McLAREN TRAFFIC ENGINEERING

LETTER OF RESPONSE TO COUNCIL COMMENTS FOR RESIDENTIAL FLAT BUILDING AT 3 WISTON GARDENS, DOUBLE BAY

Application No: DA 325/2020

FIGURE 1: PEDESTRIAN SIGHT TRIANGLE ON EXIT LANE

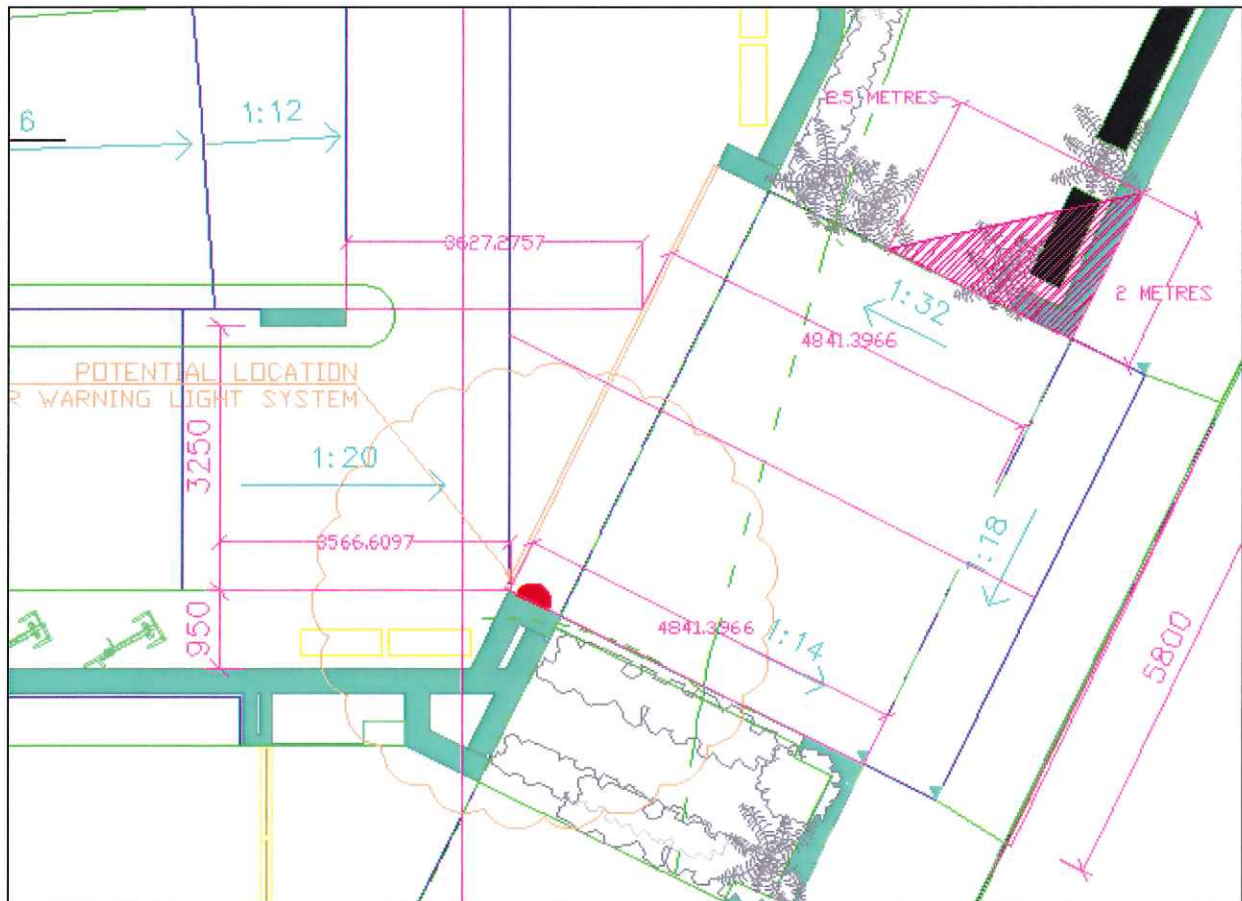
- a) *Pursuant to Clause 3.2.4 of AS2890.1, a 2m x 2.5m pedestrian sight splay, clear of any obstructions to visibility, shall be provided on both sides of the driveway exit. In this regard, any proposed structures (such as landscaping, front fences and driveway gate) located within these splay areas shall be relocated/redesigned to prevent obstructions to visibility.*

MTE Response: As shown in **Figure 1** of this letter, the pedestrian sight triangle of 2 x 2.5m is to be clear of obstructions higher than 600mm (including the proposed landscaping and front fence). This is standard practice for MTE and is based on being half the typical driver height, as per AS2890.1, being 1.15m high. It is usual and expected that a design certificate be required at the Construction Certificate stage, where this sub-600mm requirement can be conditioned as a required change for compliance with AS2890.1:2004 if it elements within the 2 x 2.5m pedestrian sight triangle shown in **Figure 1** exceed 600mm..

As per *Figure 3.3 of AS2890.1*, the sight triangle is not required on the entry (south western) side as the proposed driveway is two-lane and two-way.
